**COUNTY OF SAN MATEO
PLANNING AND BUILDING DEPARTMENT**

SUBJECT: EXECUTIVE SUMMARY: Consideration of a Design Review Permit, a Non-Conforming Use Permit, and a Fence Height Exception, to allow construction of a 1,454 sq. ft. addition and a major remodel which includes a new second story addition and an attached 400 sq. ft. garage to an existing 1,150 sq. ft. single-family residence on a non-conforming 7,540 sq. ft. legal parcel at 4028 Jefferson Avenue in the unincorporated Emerald Lake Hills area of San Mateo County. The Non-Conforming Use Permit is required for the new garage to maintain a 3-ft. right side setback (where 7.5 ft. is the minimum). The Fence Height Exception is required to legalize a 6-ft. fence in the front yard were 4 ft. is the maximum. No significant trees are proposed to be removed.

County File Number: PLN 2016-00055 (Schneider)

Location: 4028 Jefferson Avenue, Emerald Lake Hills

2 SITE PLAN 1" = 10'-0"

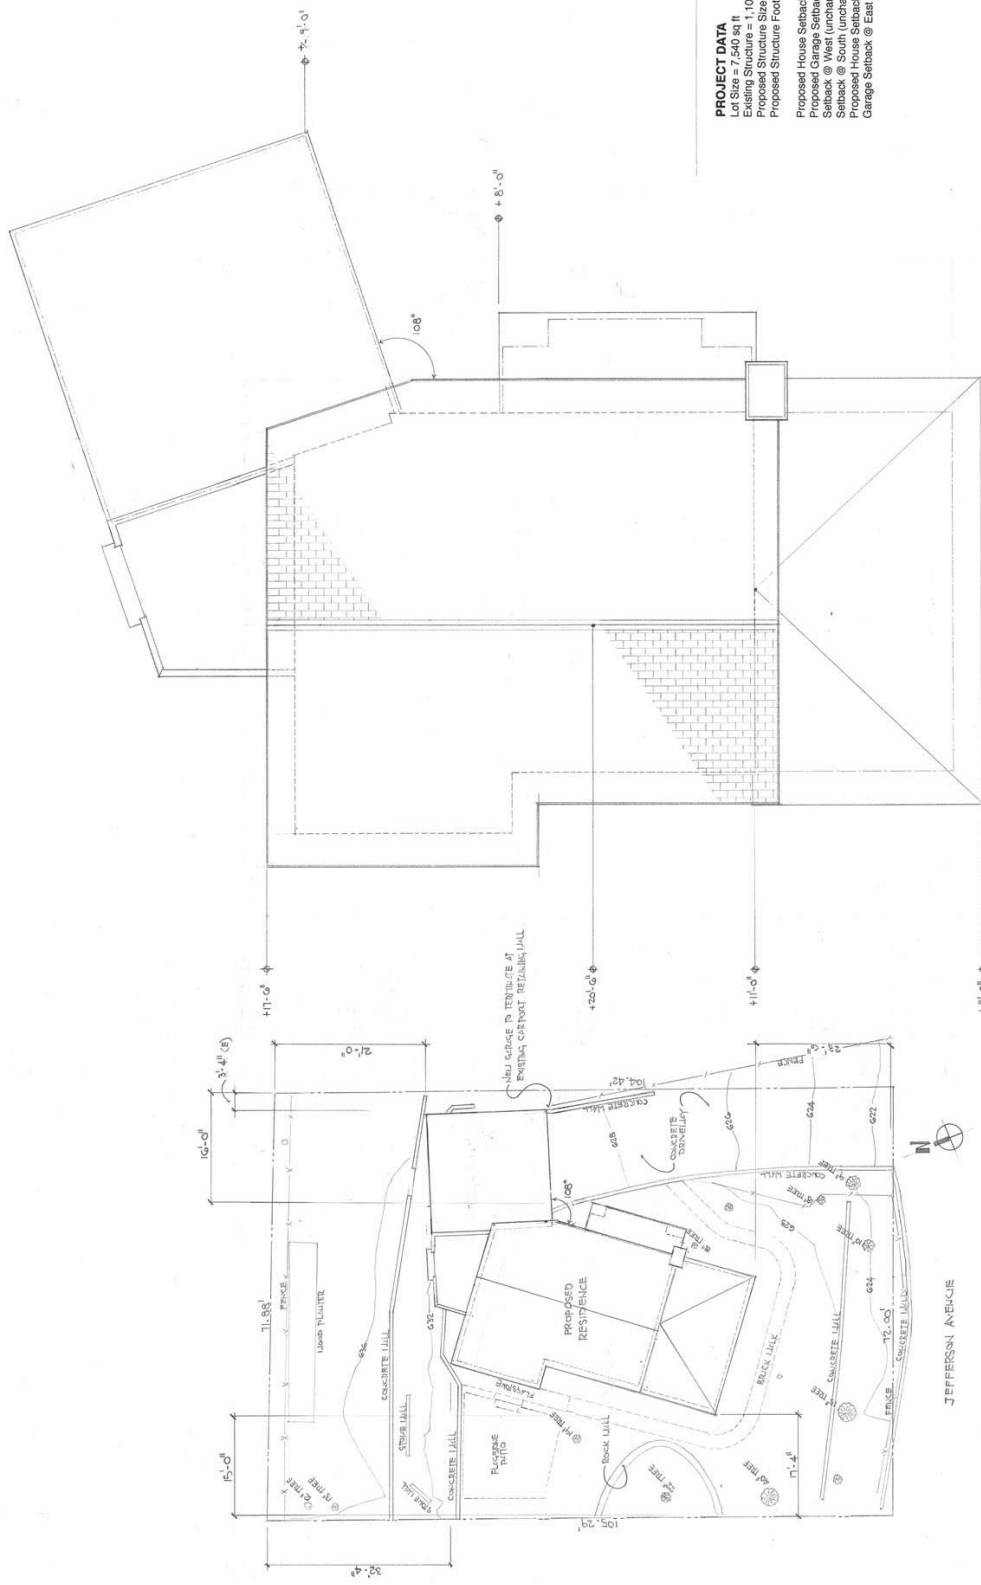
As shown above, the project complies with all requirements of the RH Zoning District with the exception of the right side setback. The new attached garage is proposed to be located within the required 7.5-ft. minimum side setback and will maintain a 3-ft. setback. The garage also allows the development to conform to the parking requirement of two covered parking spaces. This area of non-compliance is discussed in further detail in Section A.4 of this report.

The proposed development on-site includes a two car garage in the location of the one-car carport. The carport was not constructed with

permits and does not maintain the required setbacks, nor does it meet the County's parking requirement for two covered parking spaces with dimensions of 9 feet by 18 feet. The proposed garage requires a use permit as it does not meet the minimum 7.5-ft. side setback.

The new garage is being proposed in the same location currently occupied by an unpermitted carport, with the same 3-ft. side yard setback. Although the carport was not authorized by the County, it has existed for an indeterminable number of years in this location. The carport's historical existence will reduce the impact of the garage with a 3-ft. setback, since the proposed location and the use of the area will be similar to the current one. In addition, the increase in the number of off-street parking spaces is a benefit to the community as parking in Emerald Lake Hills is often a concern.
